Memo

Agenda Item: Authorize Change Order No. 5 with LaRiviere, Inc. for the Honeysuckle Avenue and Ramsey Road Roundabout Project for changes related to private utility delays and conflicts, pedestrian access revisions, a deductive adjustment for water facility testing, a deductive adjustment for resident project representative costs for Saturday work, and a time adjustment to ensure that added contract days fall on working days for a net cost decrease of \$6,108.43 and twelve (12) added contract days.

CONTRACT CHANGE ORDER NO. 5

PROJECT: 41014.14 - HONEYSUCKLE AVENUE AND RAMSEY ROAD
ROUNDBOUT IMPROVEMENTS

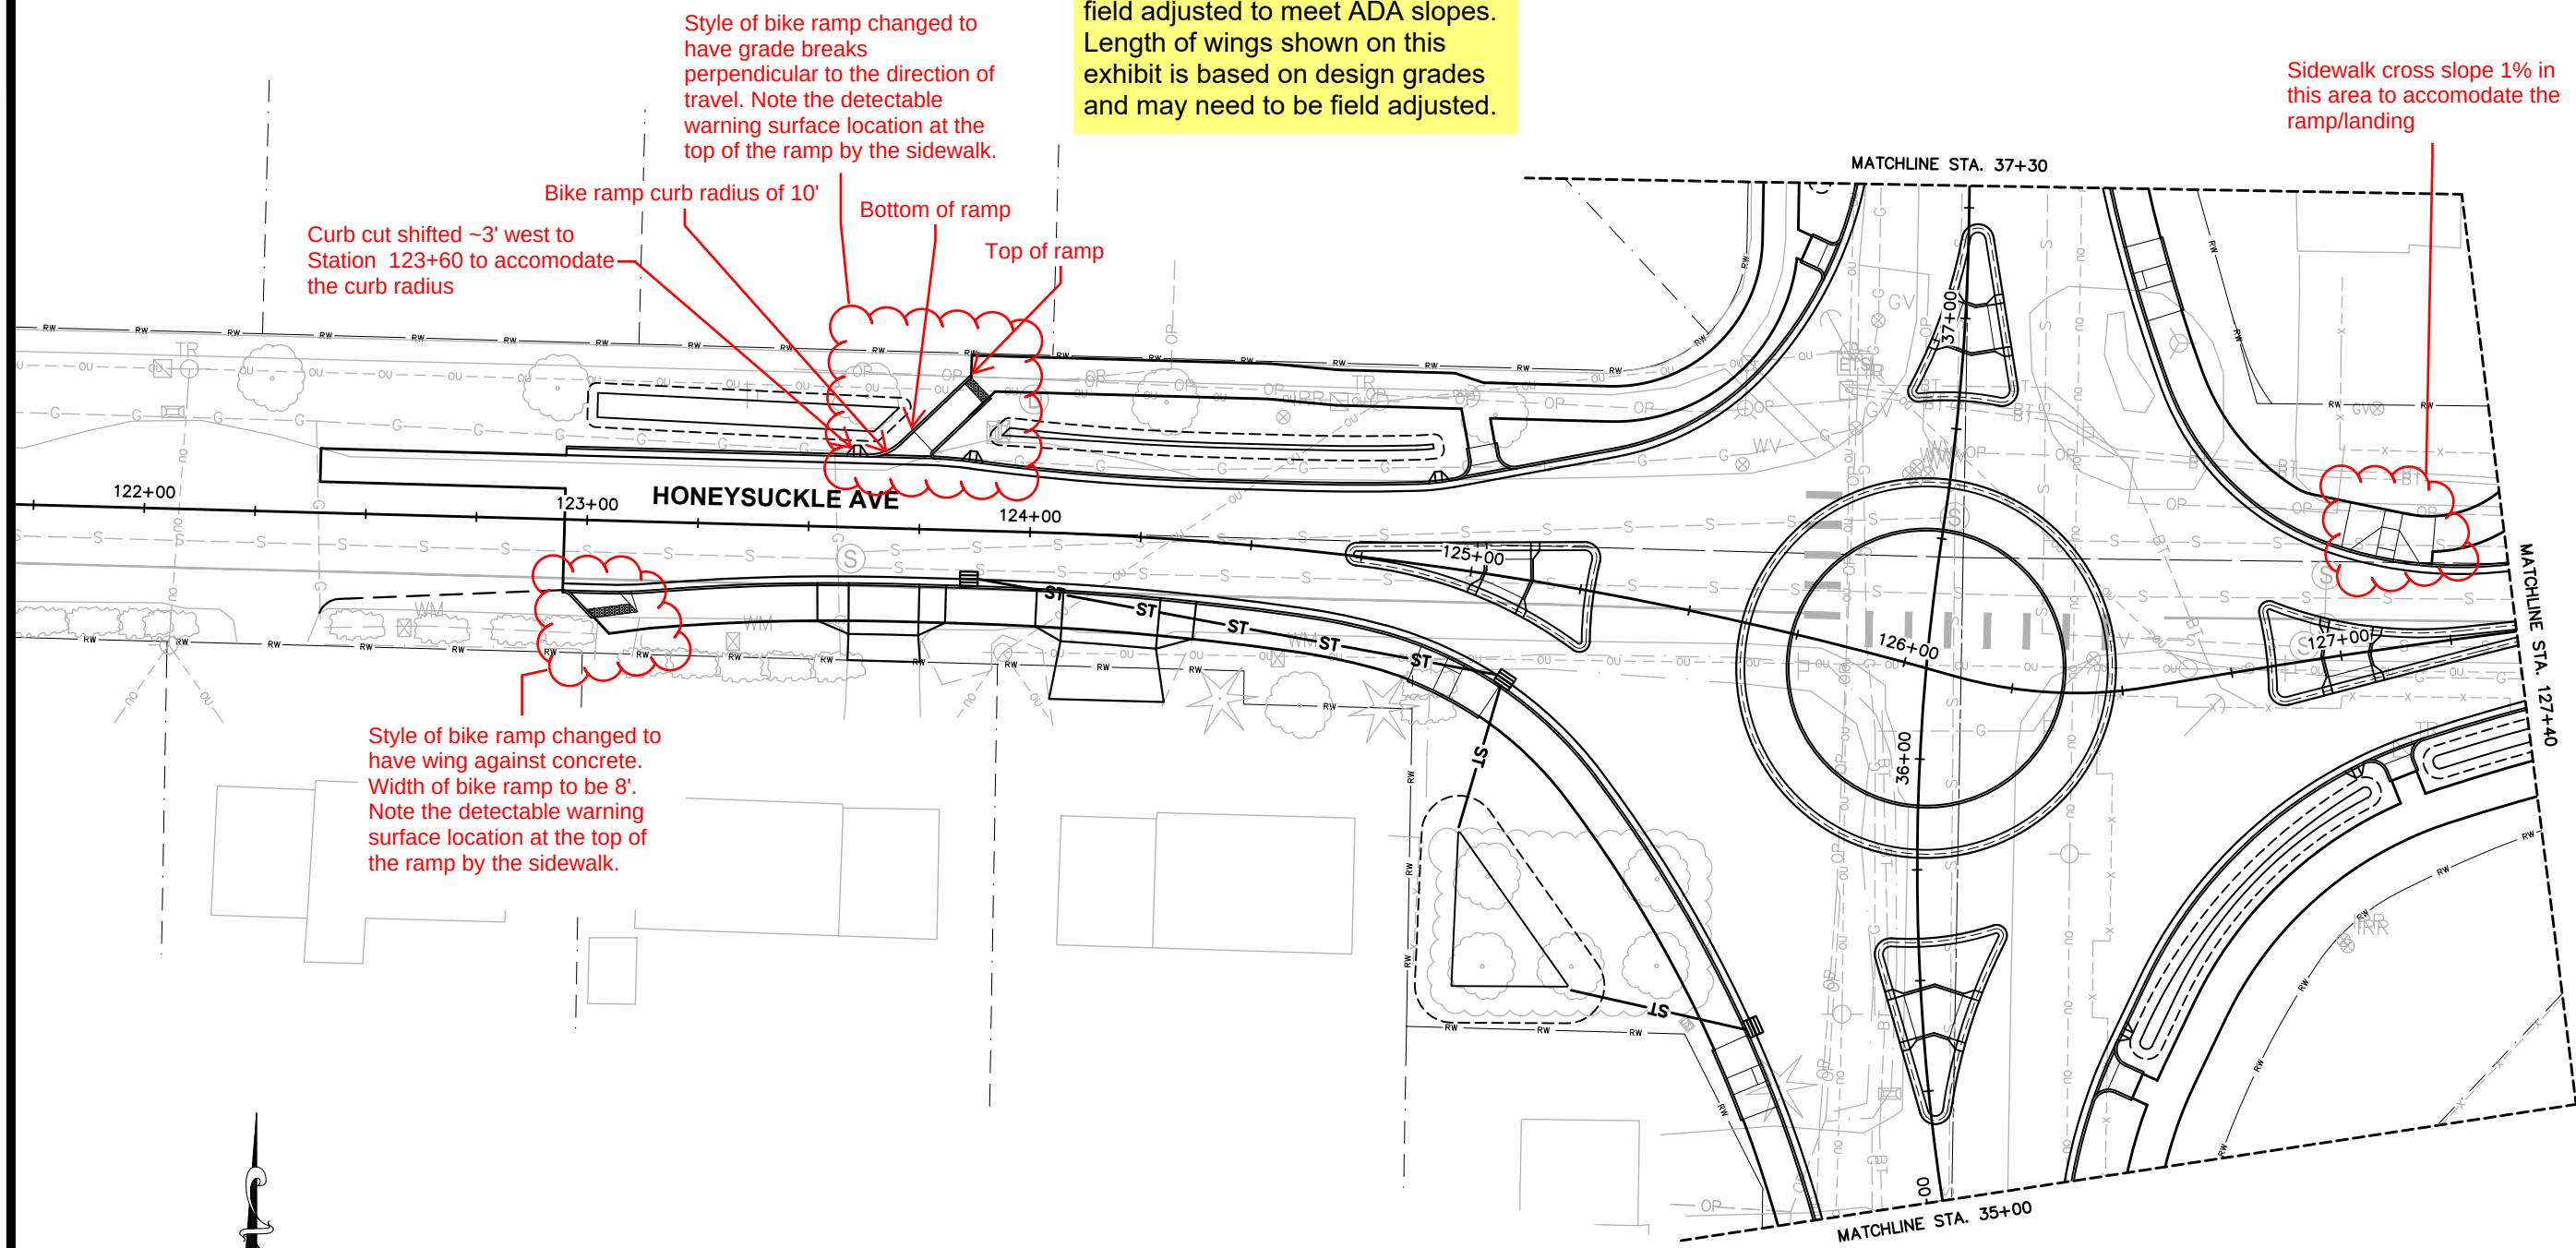
Refer to attached exhibits for modifications to ped ramp style, approach style, and adjustments to sidewalk. Any adjustments to quantities will be noted and paid at unit cost.

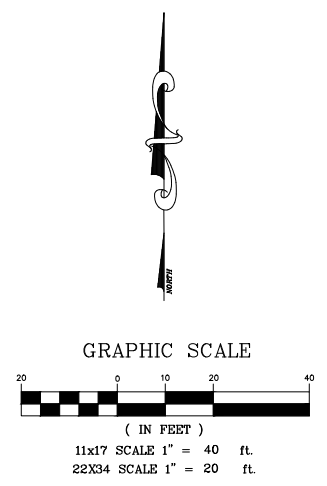
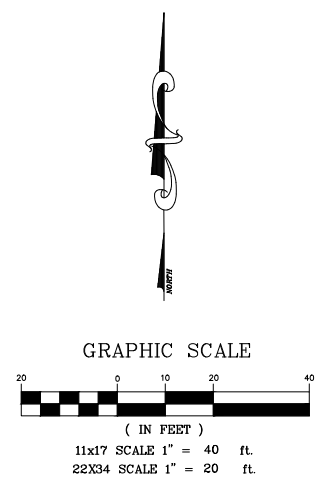
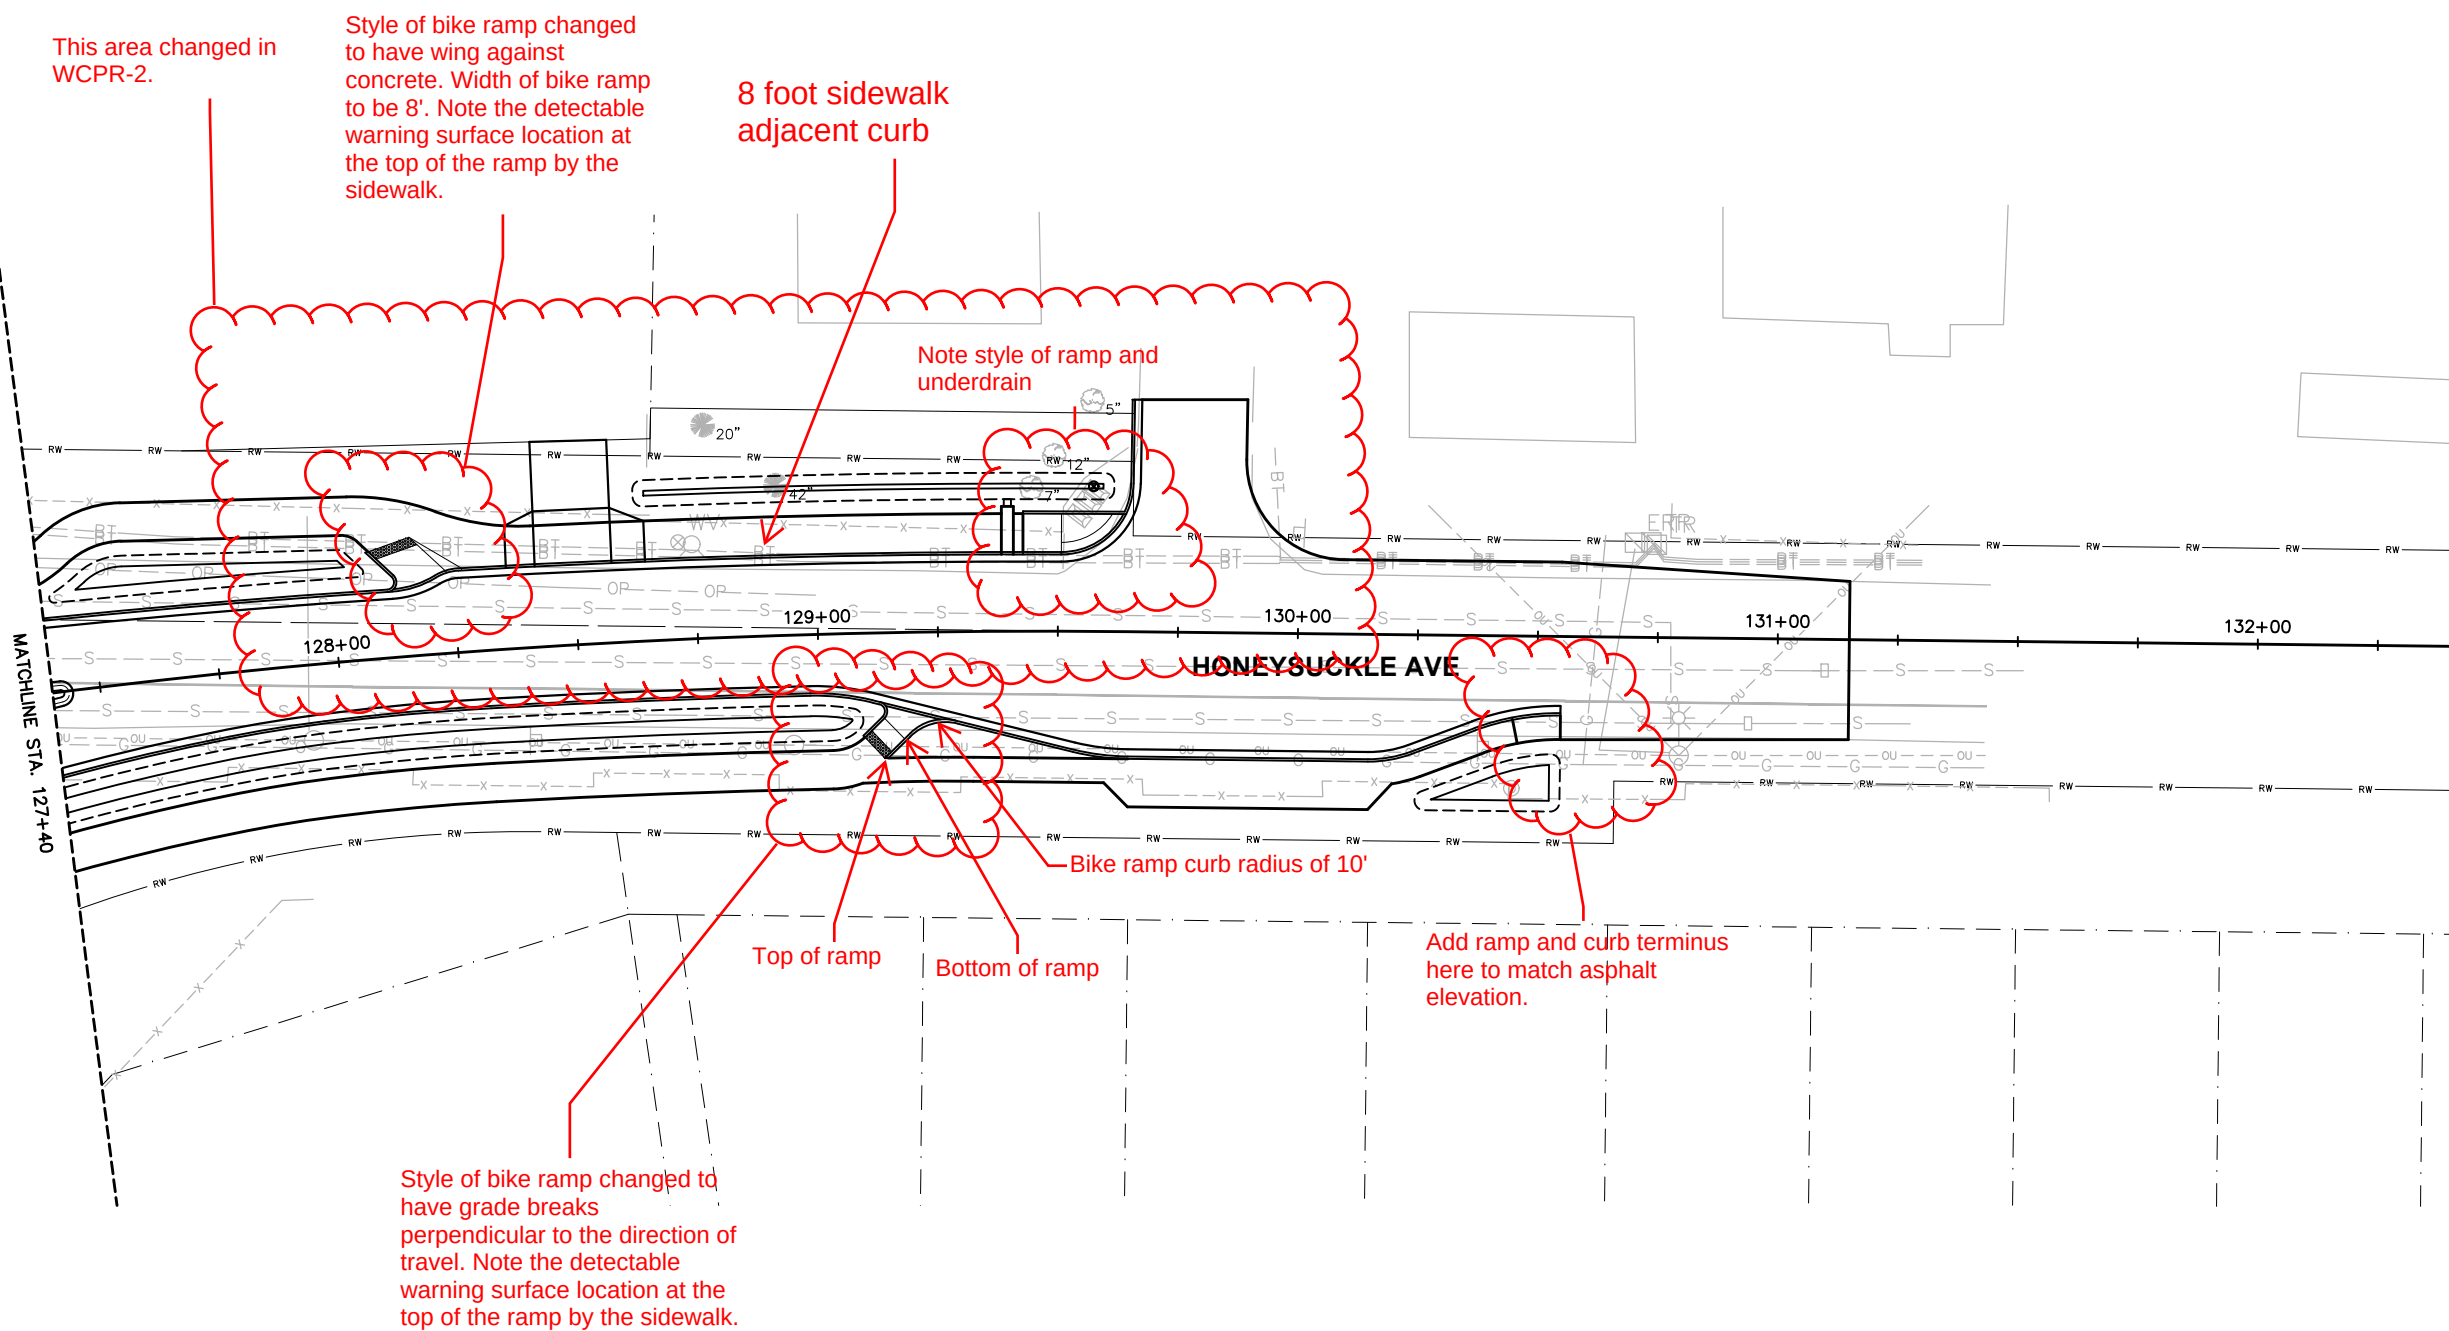
Curb cut shifted ~3' west to Station 123+60 to accommodate the curb radius

Bike ramp curb radius of 10'

Detail 1—Preferred bicycle ramp alignment with wide sidewalk buffer

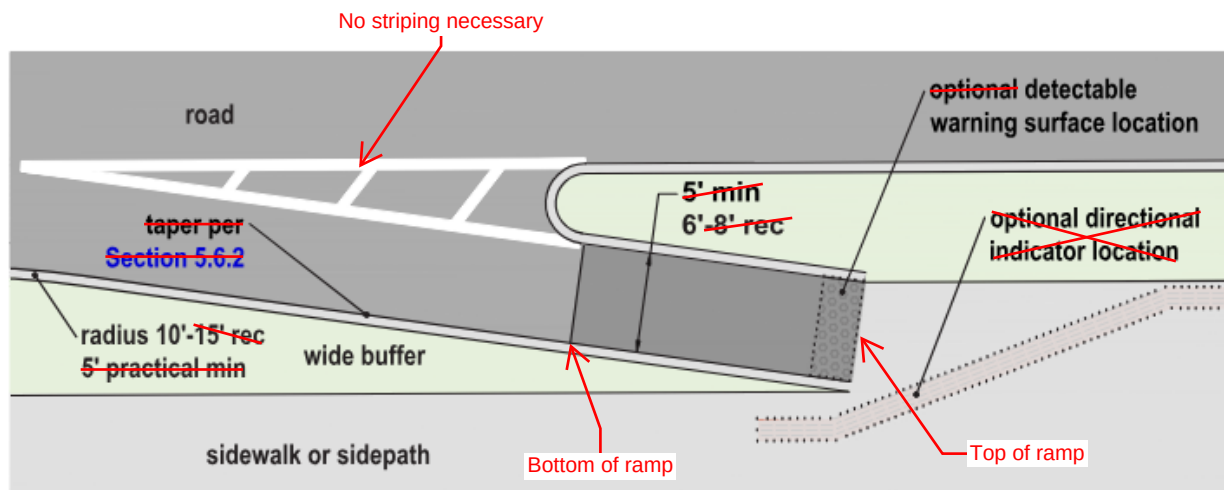
- Honeysuckle/Ramsey Intersection Plan View Exhibits (Four Sheets – West, East, South, and North Leg)
- Bike Ramp Detail

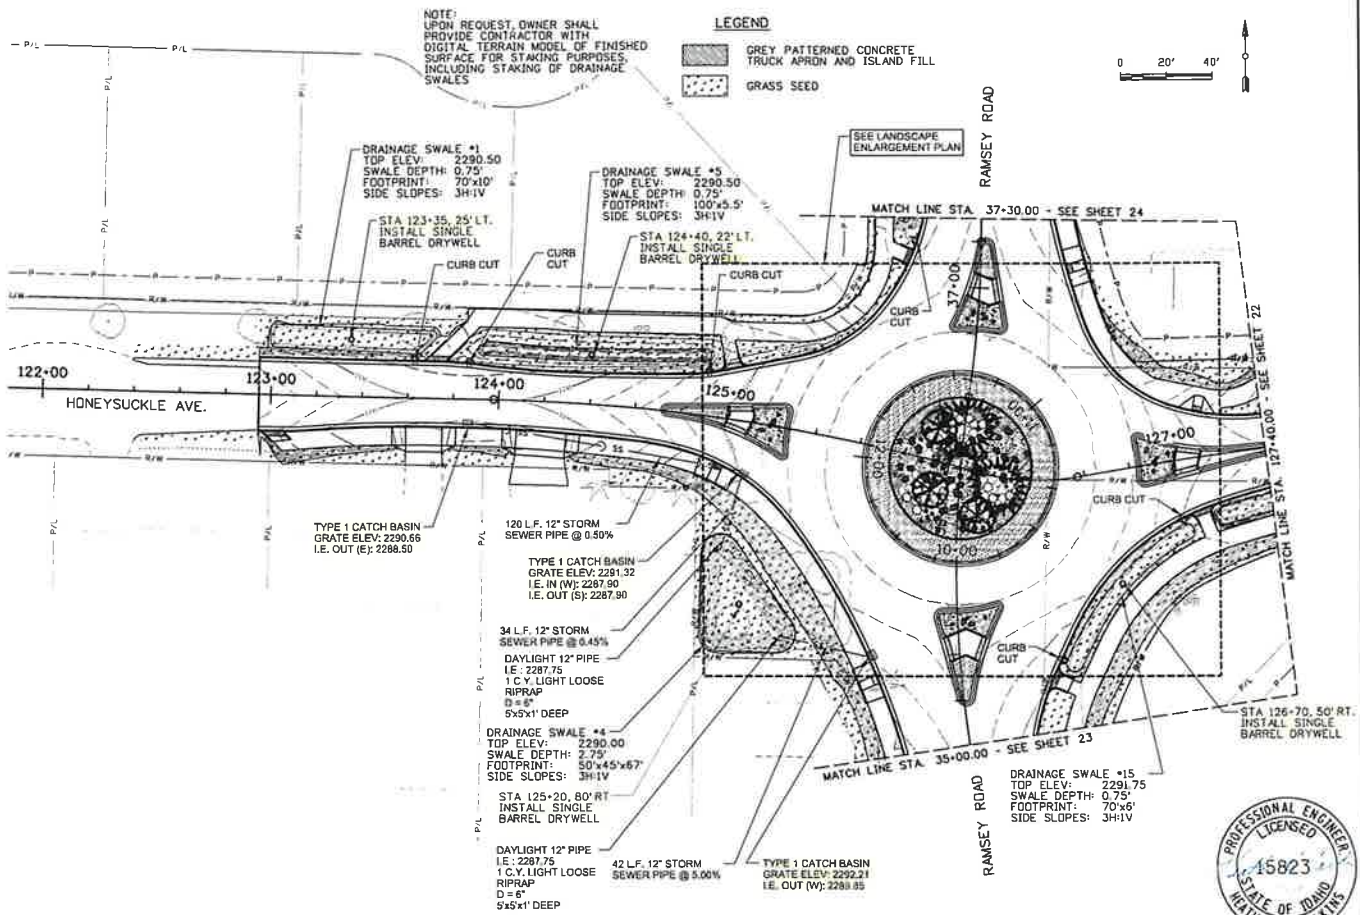
- **Sheet 21 of 44**, Sta. 123+35 LT, Power, fiber, in this location not shown on the drawings.
- Sta. 124+40 LT, Owner requested new location due to adjacent utilities, request survey of proposed new location. Track force account due to power and fiber in that location. Some what addressed in FO #4 for location. Need survey and Force account.

- Sta. 125+20 RT. Is installed per plan.
- Sta. 126+70 RT, Request force account tracked, Gas, Fiber, Power in this location not shown on the drawings. Need survey, Avista Gas wiped out

DATE:	2/18/24
DRAWN:	HEV/AC
CHECKED:	HEV/AC
DESIGNED:	HEV/AC
SCALE:	AS SHOWN
PROJECT NUMBER:	HAYF0000-0015
SHEET NO.:	22

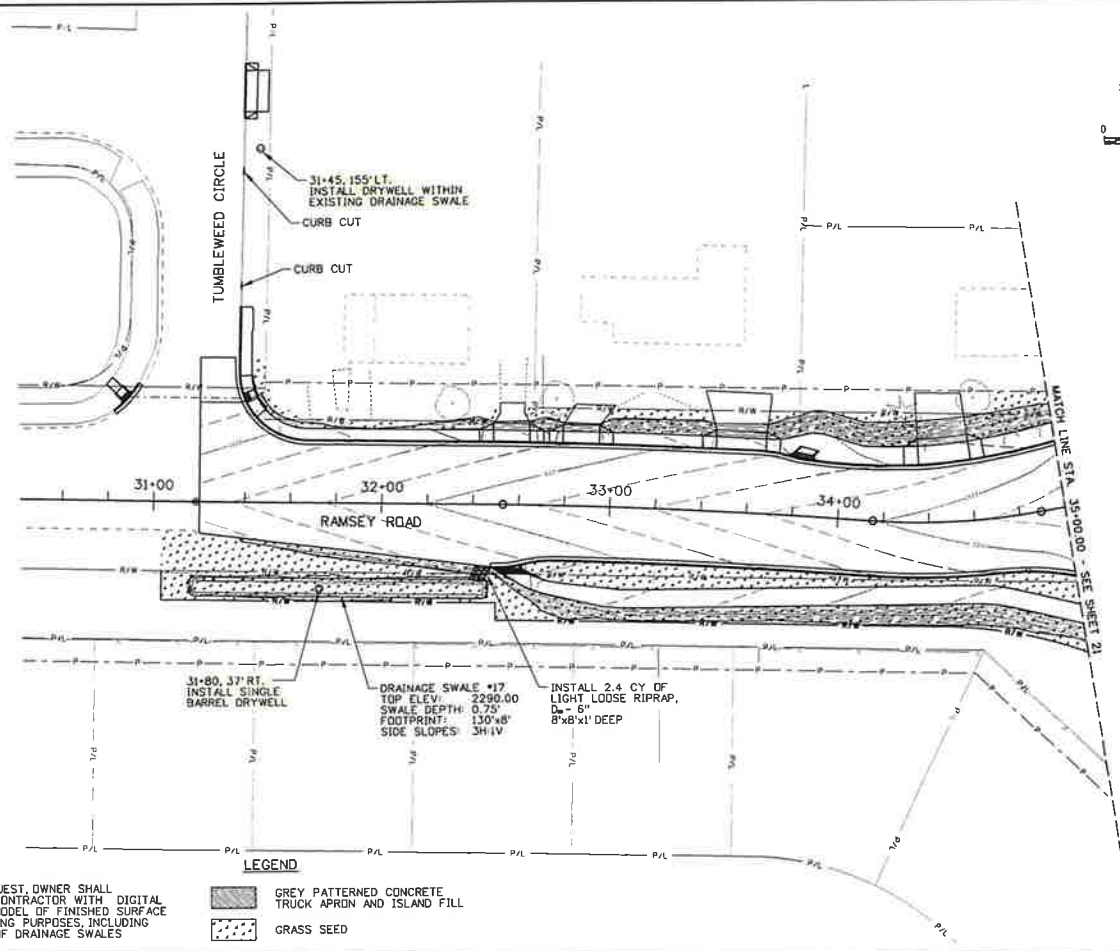
- **Sheet 22 of 44**, Sta. 127+70, Need survey, Avista Gas wiped out. Possible force account due to conflict. TBD.
- Sta. 128+80 LT, need survey, Avista Gas wiped out. Possible force account due to conflict. TBD.

- Sta. 128+30. Installed structure at requested relocation due to guide wire and other utility conflicts, In excavation for structure encountered Sewer Force main, Added 2.5 additional hours to the completion of the structure. Requesting 2.5 hours of Force account time for this structure.

- Sta. 130+45 LT. This structure is installed per plan. Encountered 2" gas main that was supposed to be abandon. 2 hours of delay for 3 people working around and stopping for the gas line repair and removal.

PROJECT NUMBER: HAYF0000-0015
SHEET NO. 23

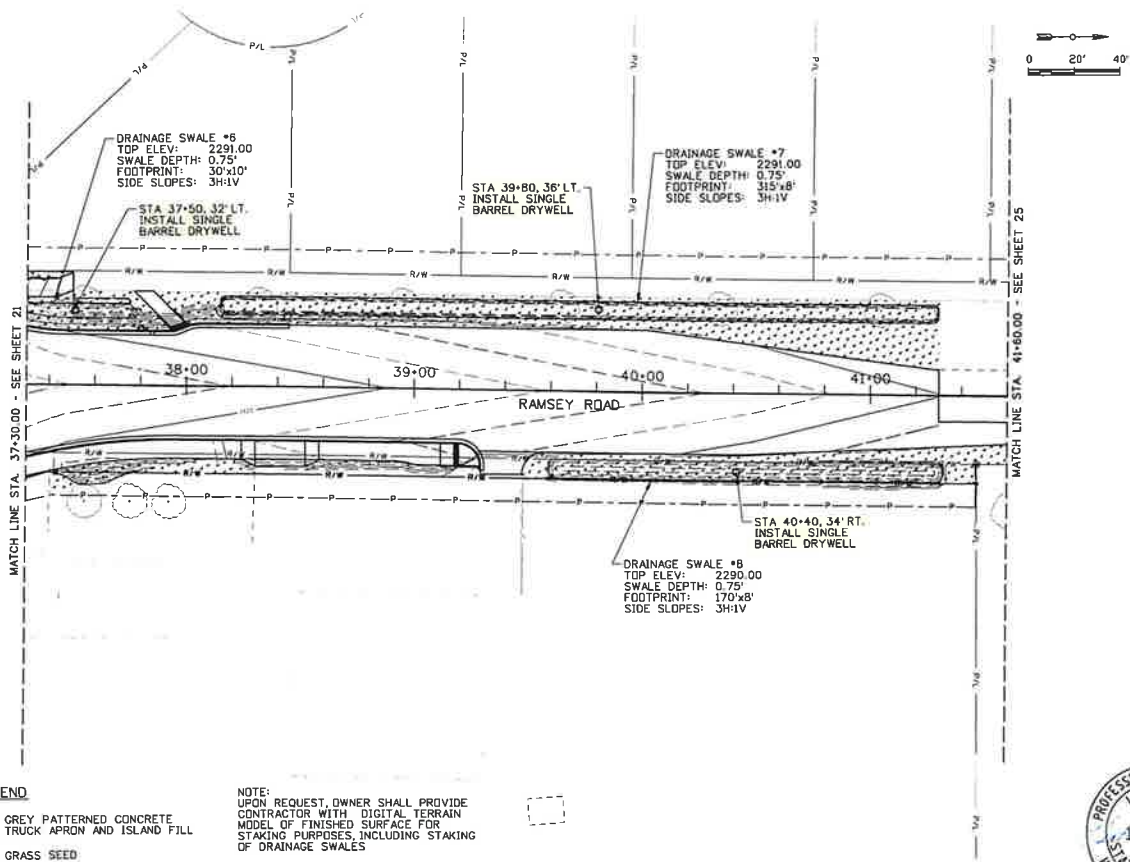
- **Sheet 23 of 44**, Sta. 31+45 LT. This dry well location has power Fiber conflicts, Request force account to be tracked exposing these lines and field fitting the structure.

- Sta. 31+80 RT. This location appears to be ok for utility conflicts and installation. TBD.
